| Universiteit Antwerpen Ontwerpwetenschappen Ambtmanstraat 1 2000 Antwerpen | | | | | Bestand: main assembly | Massa: kg |

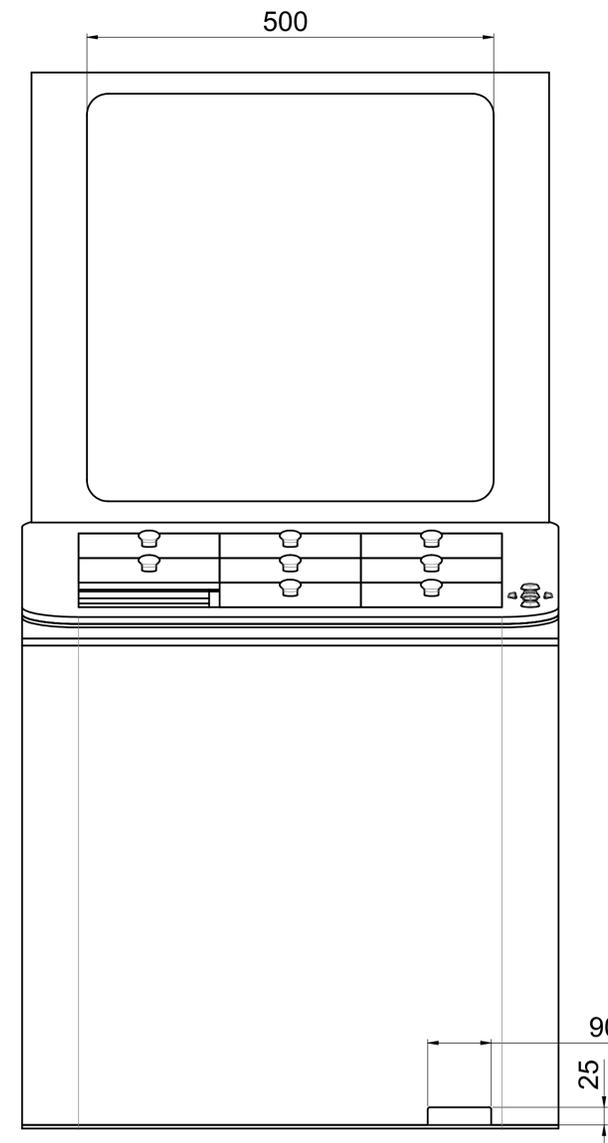
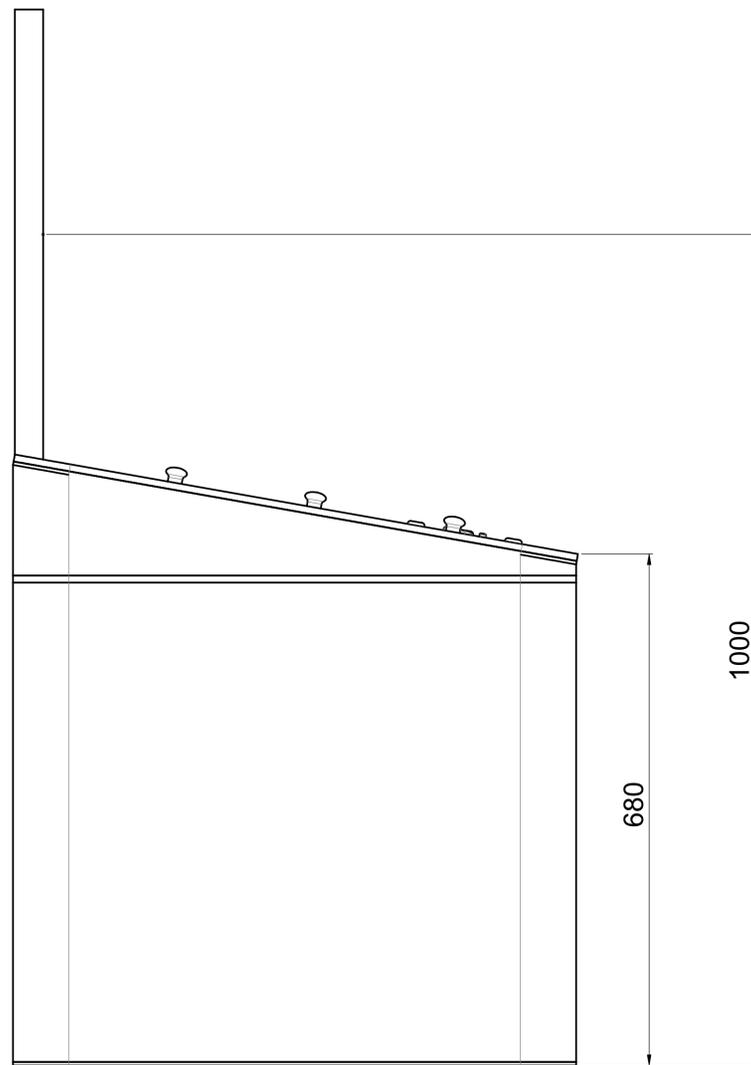
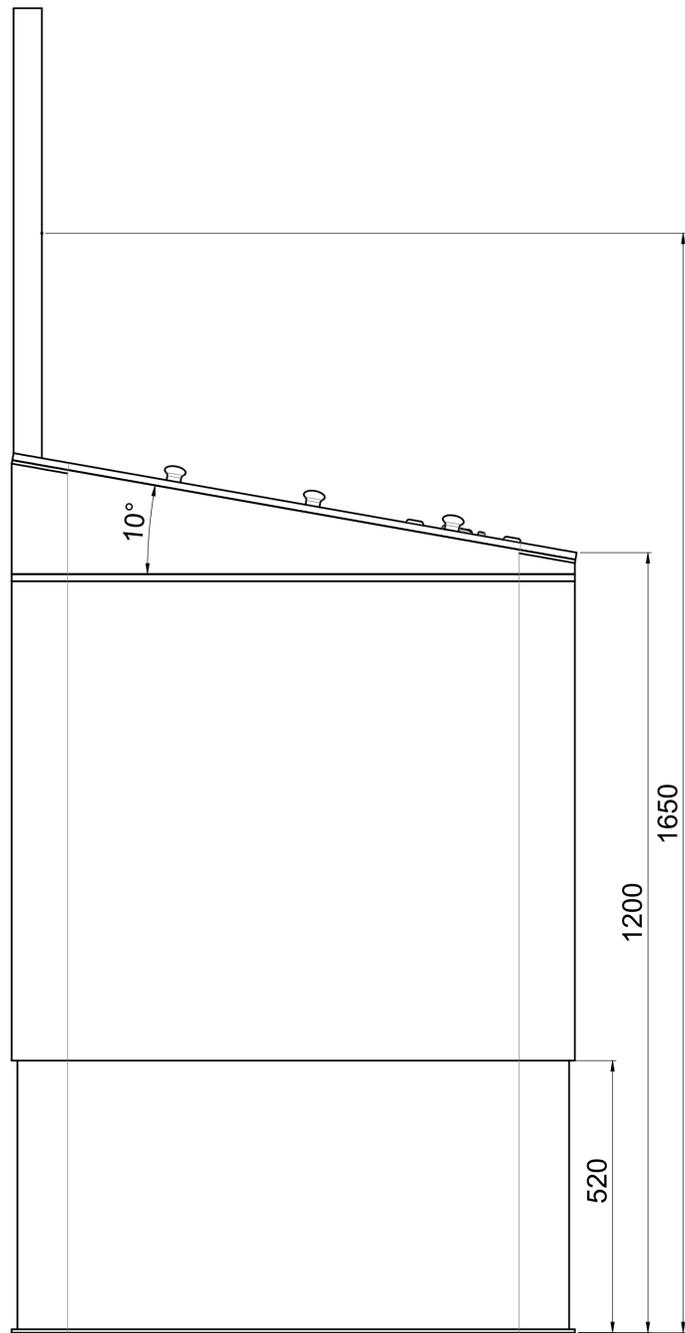
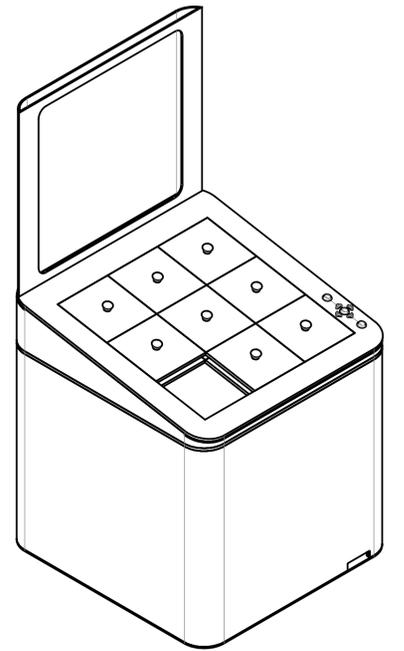
Puzzle piece handles should not have a circumference bigger than 90mm

If final screen is 21.5" 16:9 LED Backlight Monitor, dimensions are: 512 x 168 x 386 mm (W x D x H)

So hole for screen would be 500x380mm. Then a frame along the sides.

Max. force required to push down on the pedal and adjust the height is 200N.
